VSI 04/2021

Cylinder head gasket repair level
MAN TGA / TGS Engine D26

Repair level 1.50mm
Elring part number: 466.600

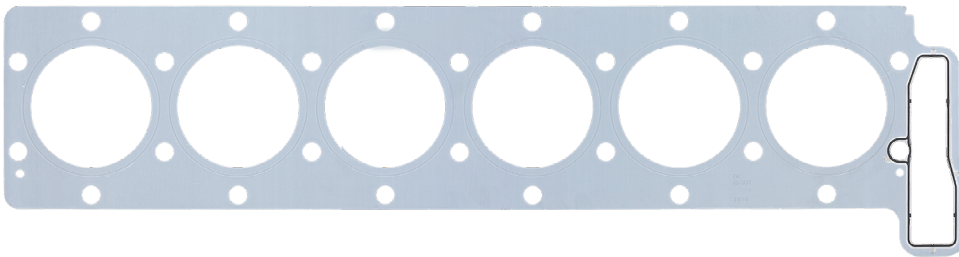
Elring is now offering a 1.5mm repair level for this engine, which has been extremely popular for years. This cylinder head gasket is 0.30 mm thicker than the gasket used in series production. All technical specifications such as the high-profile elastomer element and tolerances such as the bead height of the combustion chamber gasket, are complied with.

The cylinder head gasket can be identified with the note "Rep +0.3" of the corresponding Elring part number on the top of the gasket.
